City of Ryde Submission

Triniti Lighthouse Build-to-Rent, North Ryde- SSD-55844212

Submission Date: 17 November 2023

Figure 1: Markup of North Ryde Riverside Neighborhood Framework diagram (Base Source: Macquarie Park Structure Plan)

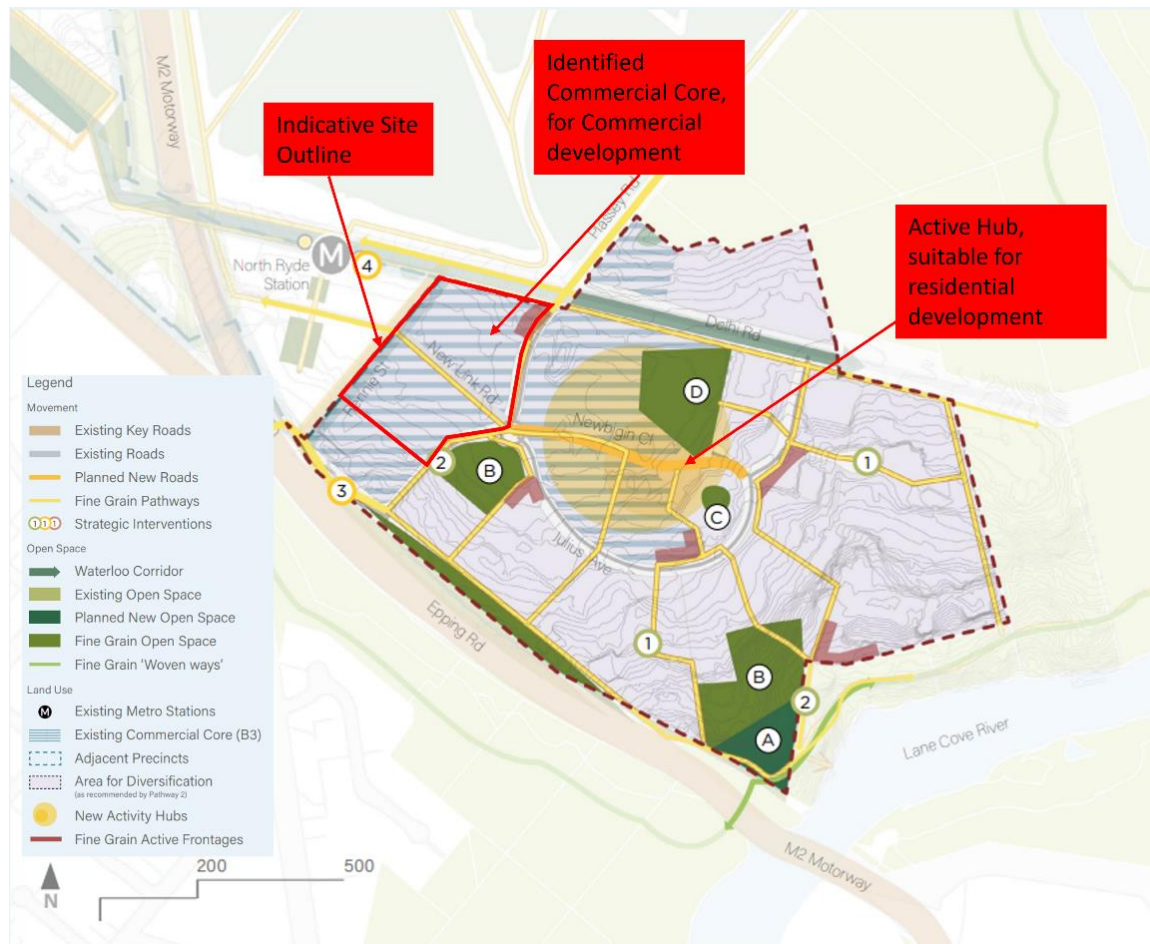
- Specifically, the Place Strategy states that for the North Ryde Riverside Precinct, 'inside the commercial core, there is the opportunity to explore residential uses within the identified activity hub'. The subject site is not located within the identified activity hub; therefore its proposed residential use is not supported by the Place Strategy. (Figure 1)

Figure 5: Markup of Structure Plan for Precinct 7 (Base Source: Place Strategy and Masterplan Macquarie Park)

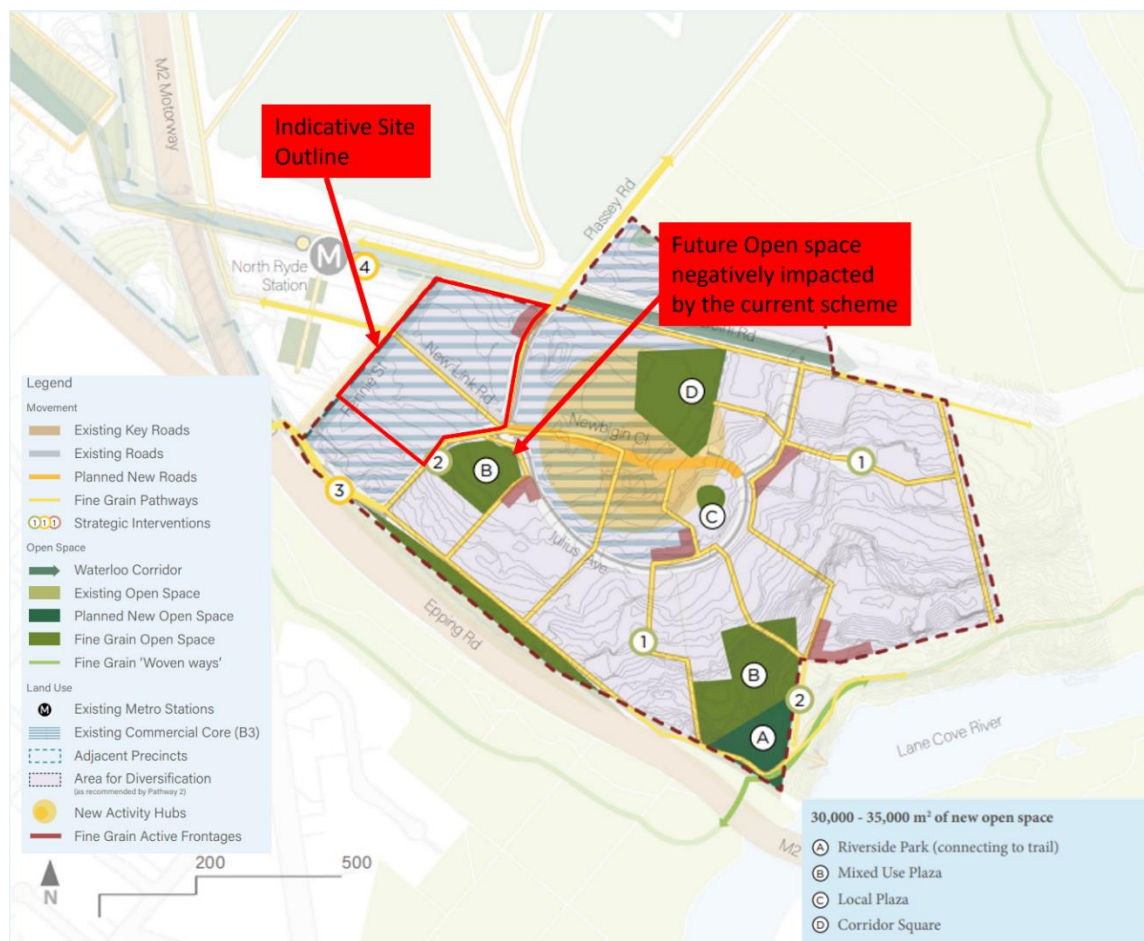
- Council further notes the impact of the buildings design on the mixed-use plaza outlined in the Place Strategy. The current built form outcome severely compromises sunlight and aspect to the future open space (Figure 5). Of particular importance is the design criteria that requires sunlight protection to this area as follows:

The submitted EIS provides rationale as to why severely compromising this solar access is acceptable, however Council does not accept this, as an improved design outcome on the site, could ensure amenity is retained for this important open space. The suggestion that little weight should be given to this is inappropriate. Part of the consistency test required by Clause 35 of the EPAR 2021, would be consideration of this control. In this regard, the open space is **NOT** demonstrated to have solar protection. Council does not accept the impact to this space when a more considered design approach could occur to ensure the retention and protection of solar amenity to this space.

Figure 7: Mark up of Windtech Figure 6 showing Level 20's recommendation (Base Source: Windtech)

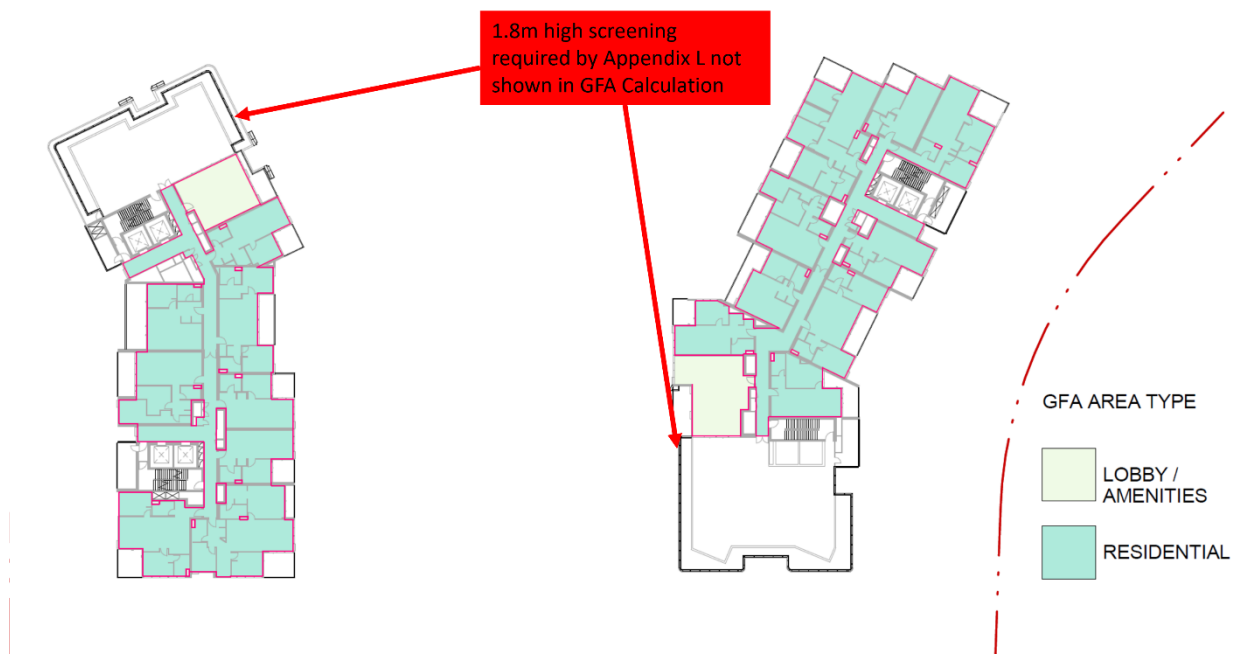
- *Retention of the proposed impermeable balustrades*
- The above recommendations outlined that full height impermeable screening is to be provided around communal open spaces and certain private balconies. It is unclear if these elements have been drawn into the design, however what is clear is that the Applicant has not included these spaces into their GFA Calculations. As per the definition of GFA, screening higher than 1.4m would be included in GFA. An example is demonstrated below for the communal open space on level 20 refer Figure 7 & Figure 8 .

Figure 10: Markup of Stormwater Plan

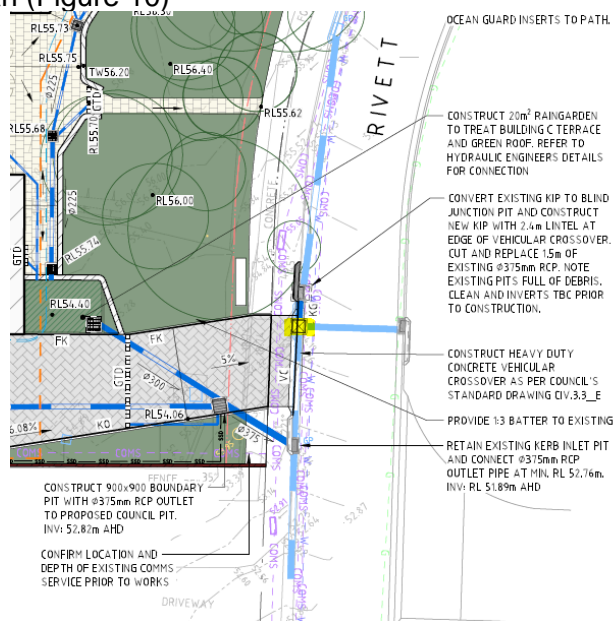
- Council requests that the Stormwater management plan dated 18 August 2023 be amended to reflect the following:
- Please provide clarification of the new proposed pits. It is unclear if there is a new junction pit proposed within the driveway. Please show the new and existing pits in a different layer. Details of all new drainage infrastructure (pits and pipes) to be included in the stormwater management plan (Figure 10)

Figure 11: Markup of Civil Drawing

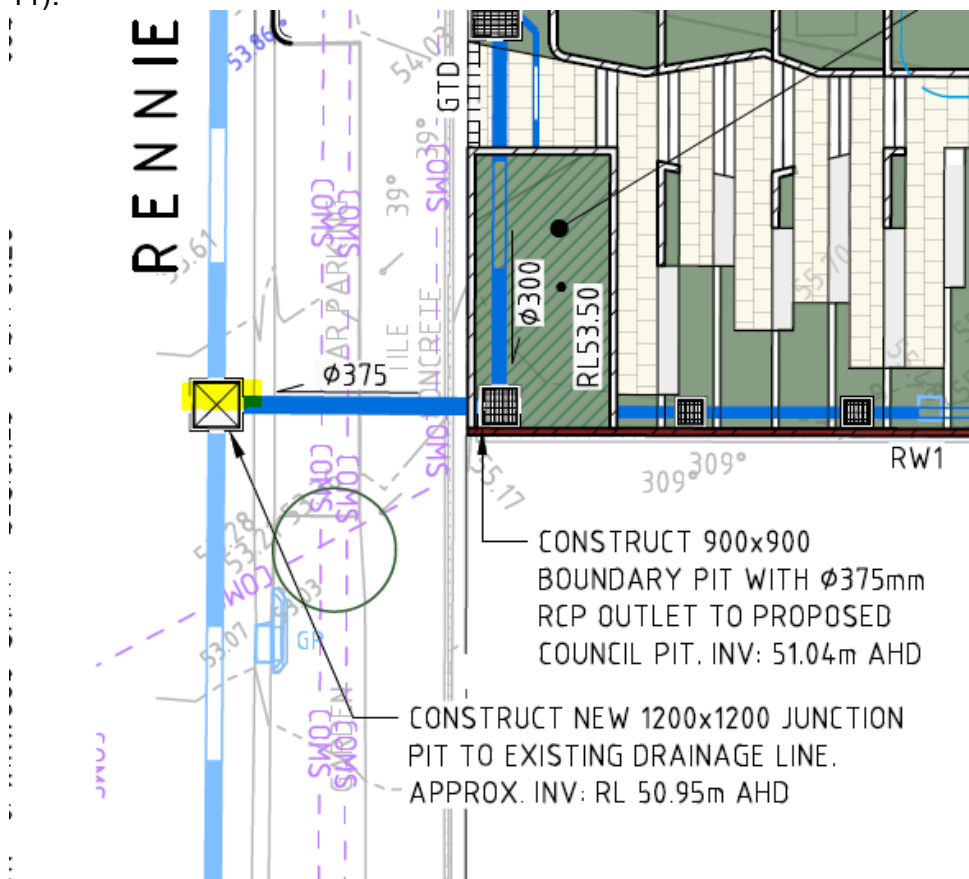
- Minimum 1% slope to be proposed for new drainage lines in Council land.
 - Existing Council drainage infrastructure details including, diameter, etc. shall be shown on the plans, including details of the connection with the proposed stormwater system.
 - Council Details shall be incorporated, from Council Standard Drawings.
 - New proposed Council pipes to include Rubber ring joints.
 - Any proposed junction pit to be constructed with concrete lid.
 - Details of the connection to Council pipe shall be included in the Stormwater Management Plan.
 - Details of all new proposed Council pits must be included in the plans. Please provide some detailed sections for clarification of the proposed drainage assets. For example, please provide a section for the new pit over Council pipe as highlighted below (Figure 11):

Figure 13: Extract Showing south façade noise prediction daytime (Source: Acoustic Logic)

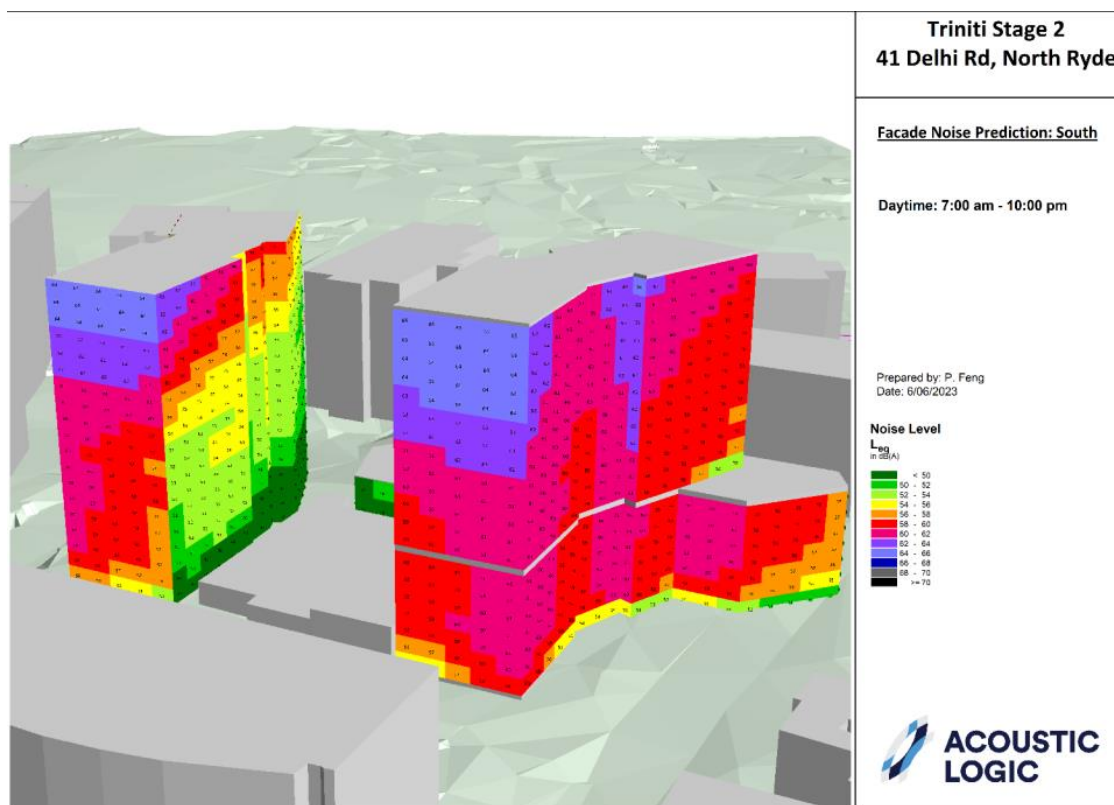
- An acoustic and vibration report has been prepared by Acoustic Logic, ref 20230459.1/1508A/R2/RF, dated 15 August 2023. Recommendations for external finishes are made with respect to glazing, roof, ceiling, walls and entry doors are made in section 6.3. It is understood that an alternative means of ventilation will be required as the internal noise criteria will not be achieved with windows open.
- The submitted acoustic assessment confirms that residential amenity will be severely compromised in certain apartments during both day time (Figure 13) and nighttime (Figure 14), due to noise impacts. This is unacceptable and the application in its current form doesn't demonstrate that there is sufficient mitigation measures and design outcomes to appropriately manage noise to ensure residential amenity isn't compromised.

Figure 15: Appendix B of Acoustic Logic – Mark up of level 3 (Source: Acoustic Logic)

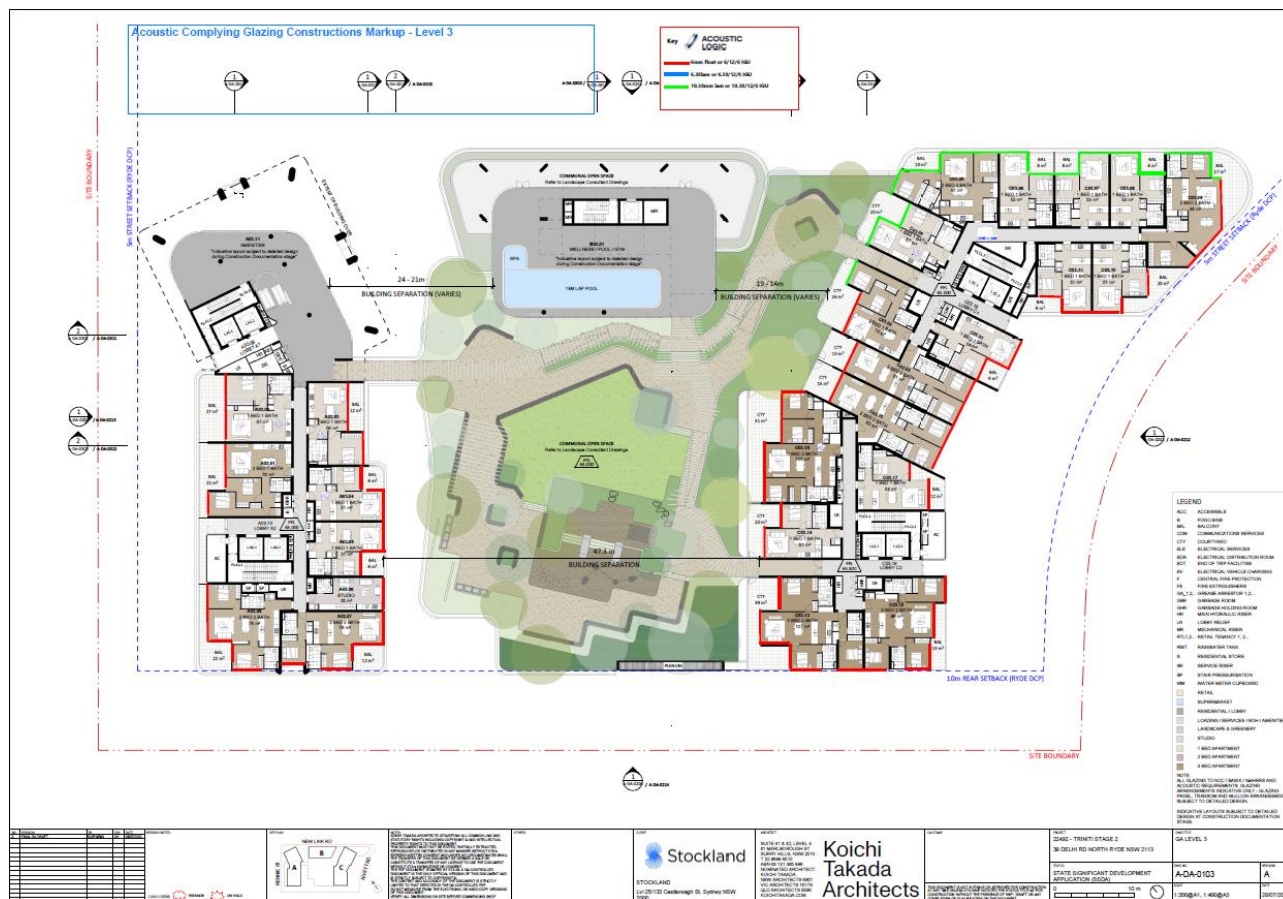
- Appendix U - Noise and Vibration Assessment does not undertake any assessment of impact of the noise and vibration caused by users on the gym and the amenity of the residential receivers. In this regard, an amended acoustic assessment is required to consider the 24-hour gym and the associated impacts and mitigation measures needed to be implemented to be situated below residential receivers. Appendix U does not propose any mitigation measures for the gym, as shown in figure 15, where no acoustic glazing is suggested below, as a simple mitigation measure. Further measures could be required, which is to be assessed in the revised assessment.

Figure 16: Shot showing left turn only from New Link Road onto Rennie Street (Source: Google Maps)

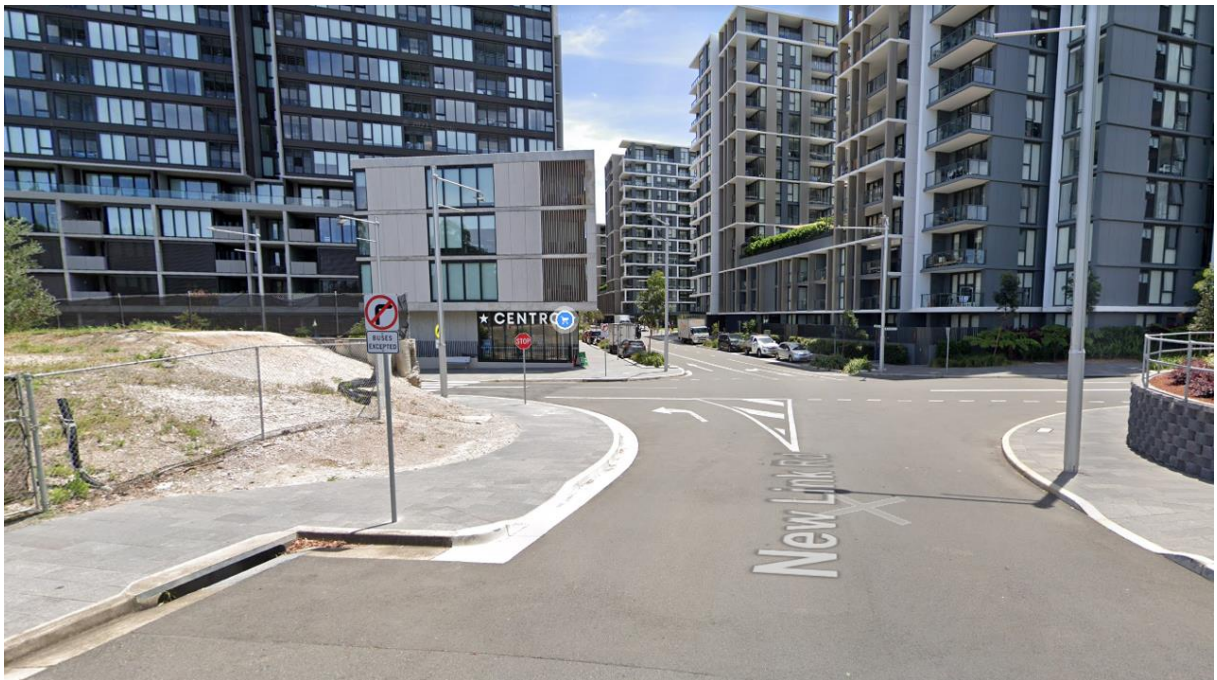
- There is no swept path assessment demonstrating that the largest/longest vehicle that could potentially access New Link Road from Rennie Street can turn around when New Link Road is closed to Rivett Road during events.
- Consideration also needs to be given to the intersection arrangement at Rennie Street and New Link Road/Network Place. The current linemarking at the intersection of Rennie Street and New Link Road forces westbound traffic on New Link Road to turn left (Figure 16) onto Rennie Street which is currently a dead-end road and does not have any turning circle to facilitate turnaround movements on Rennie Street. Forcing all traffic from New Link Road, onto Rennie Street will result in a significant bottle-neck, in its current form as its closed.
